Interactive comment on "Global scale human pressure evolution imprints on sustainability of river systems" by S. Ceola et al.

Response to Wouter Berghuijs (Referee)

Response to Anonymous Referee #2

Figure R1. Standardized human pressure on rivers: preliminary results using time varying discharge data to compute the evolution of human pressure on river systems across four catchments in China and Myanmar. A comparison with constant discharge values is also shown.

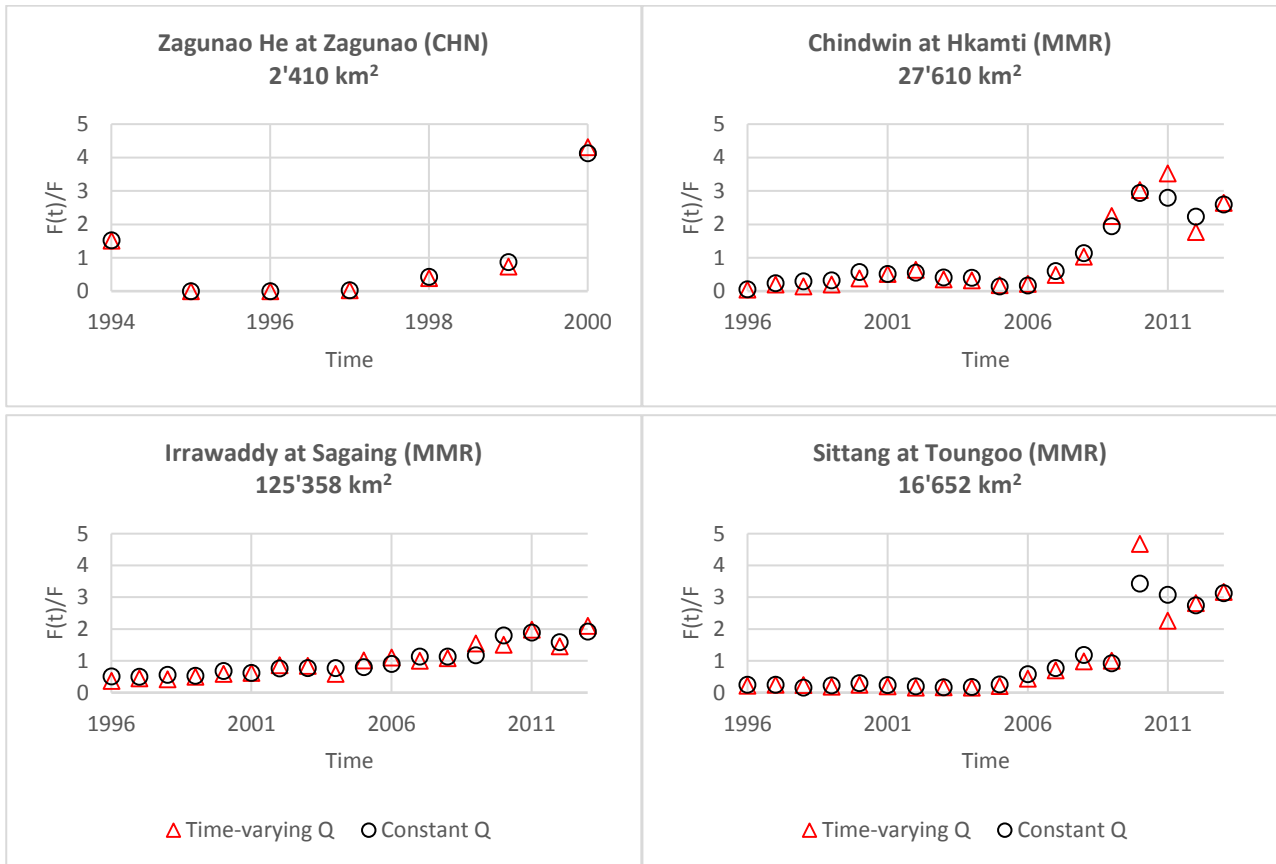
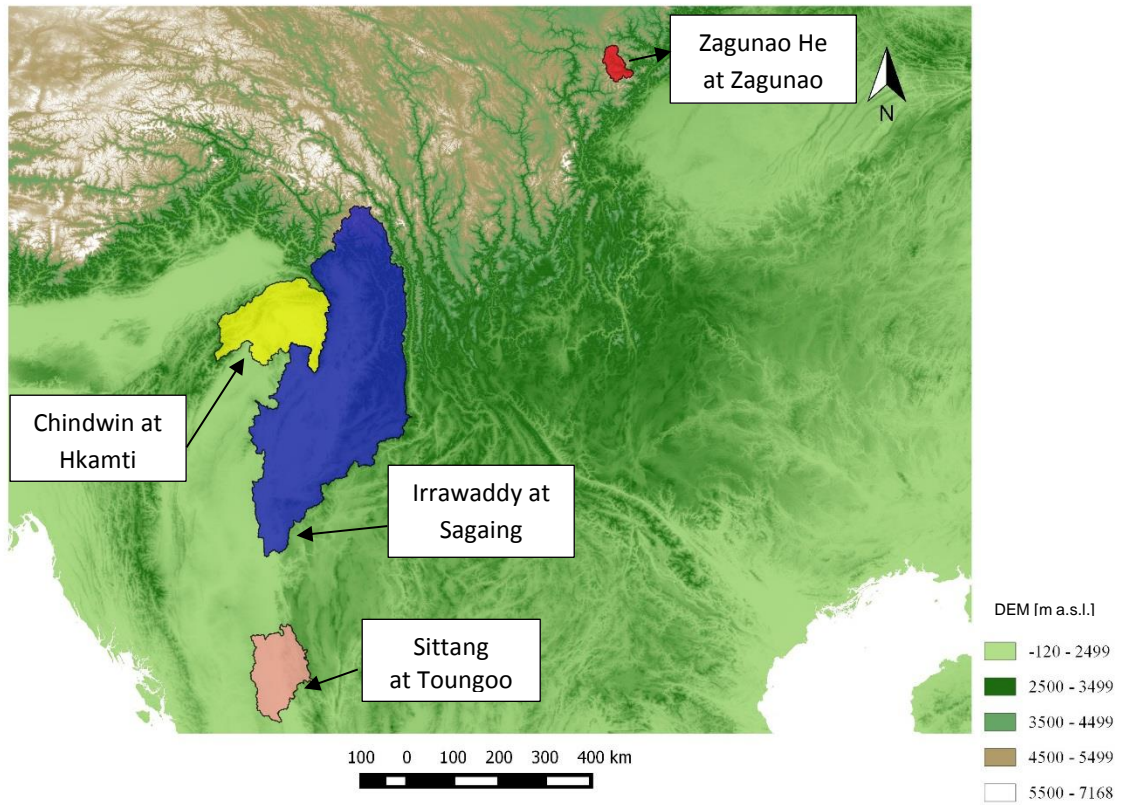
****Why normalize by river discharge?*** It seems that changes in pressure on river systems (DHPR) are mathematically independent of a location's discharge (since DHPR looks at relative changes and runoff is assumed constant per location). Thus, the "Differential Human Pressure on Rivers" solely quantifies changes in nightlight data along a river network. This is not wrong, but this does not match the description that is used throughout the paper.*

We normalized by river discharge to distribute human presence and activity on natural available discharge, following the approach developed by Vörösmarty et al. (2010). DHPR is based on the analysis of the temporal evolution of standardized human pressure on rivers $F_i(t)$, as defined by Eq. (10) in the original manuscript. Standardized human pressures, and thus DHPR, are a function of the (i) ratio between human presence and activity, HP_i , and discharge, Q_i , and (ii) its minimum and maximum values, which consider both HP and Q . As a consequence, DHPR is not totally independent of Q . Our approach, as defined in this manuscript, considers stationary discharge. However, it is planned in the near future to consider time varying natural flows, to explicitly embed variations in both drivers. As an example, we performed a preliminary study on a few catchments across China and Myanmar, using discharge data provided by GRDC (Global Runoff Data Centre). Standardized human pressures on rivers are reported in Fig. R1, where a comparison between time varying and constant discharge is shown.

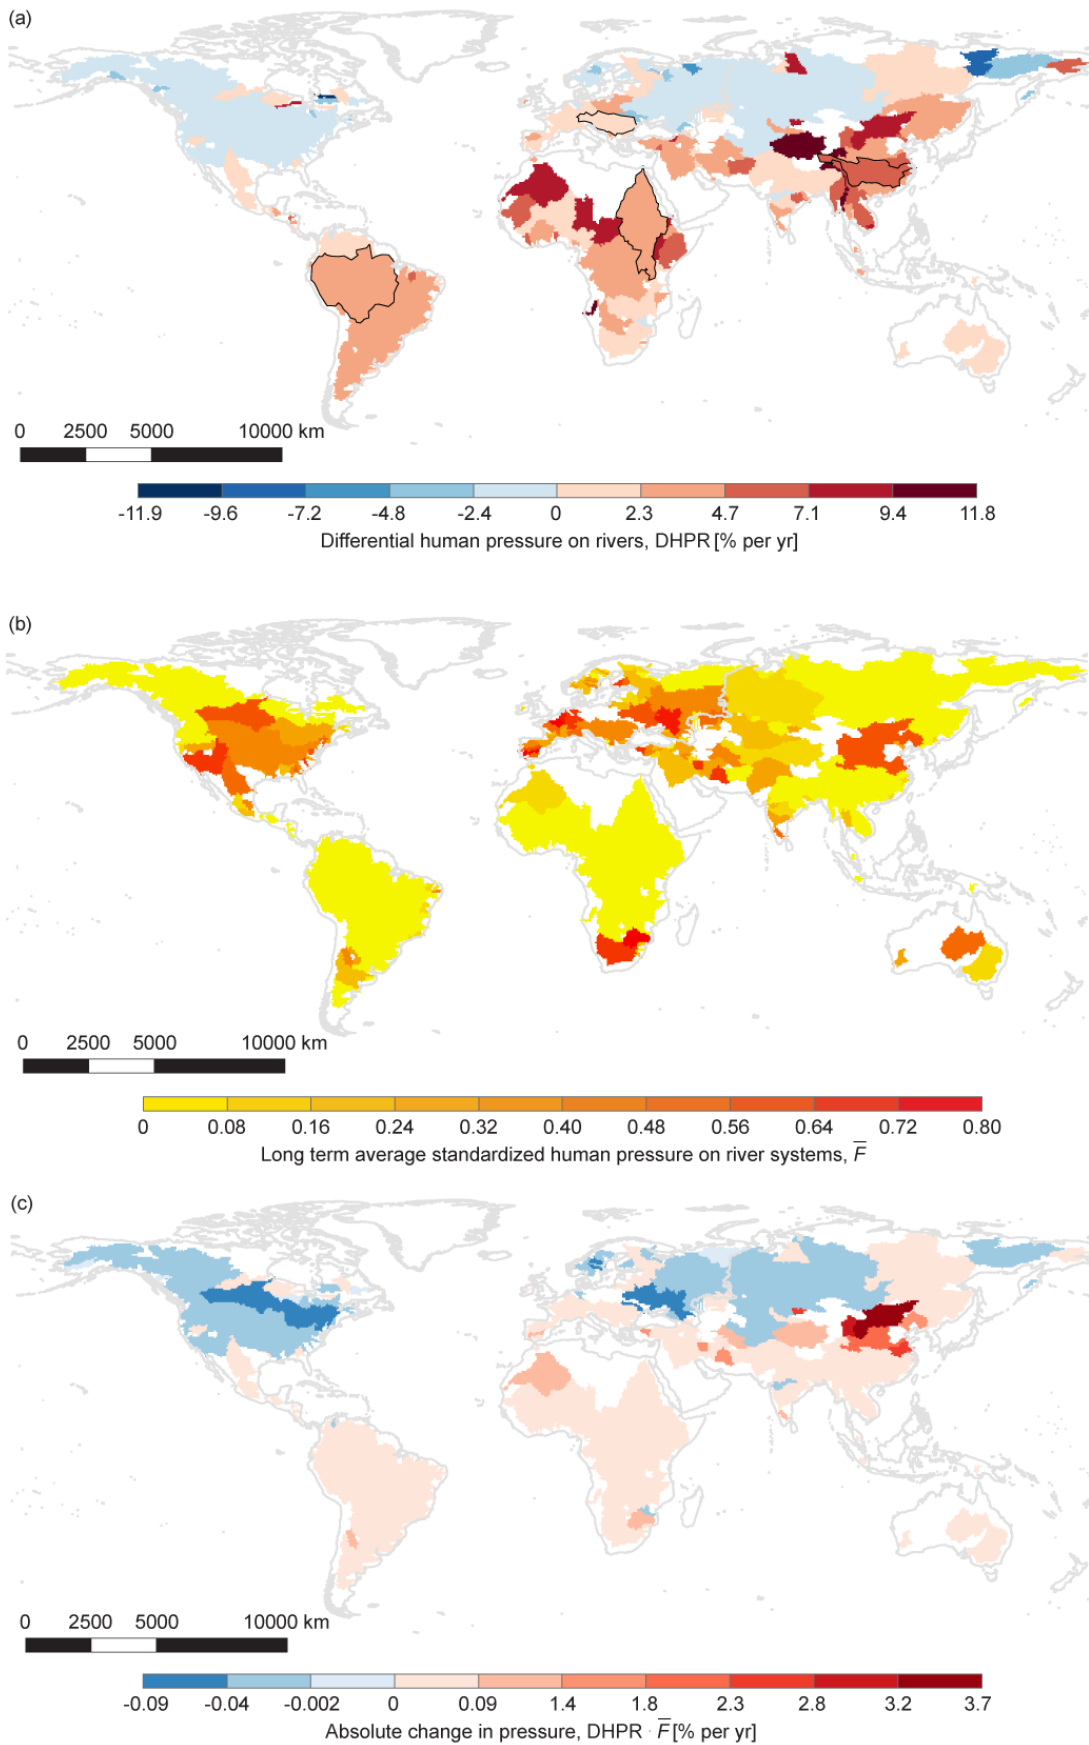
****What makes a hotspot a hotspot*** Hotspots can be identified based on absolute pressure, or changes in pressure. The focus in this paper seems on the latter. However, these are all “relative changes” in pressure, but is a relative change really relevant when the “absolute pressure” is very low”?*

Thanks for this comment. To better explain this issue and reply to your question, we show in Fig. R2 a comparison among (a) the relative change in pressure, DHPR, (b) the long term average standardized human pressure on river systems \bar{F} , where the value at the outlet is uniformly distributed across each river basin, and (c) the absolute change in pressure, as the product between DHPR and \bar{F} . Marked absolute changes in pressure are evident only for river basins with relatively high standardized human pressures. These absolute changes, expressed

as % per year, are evidently proportional to absolute pressures and thus it is not possible to compare trends across basins. We used normalized values of human pressure in order to compare trends at global scale, independently from absolute human pressure values, which are influenced by catchment size, human presence and activity (namely, the sum of nightlights) and discharge.
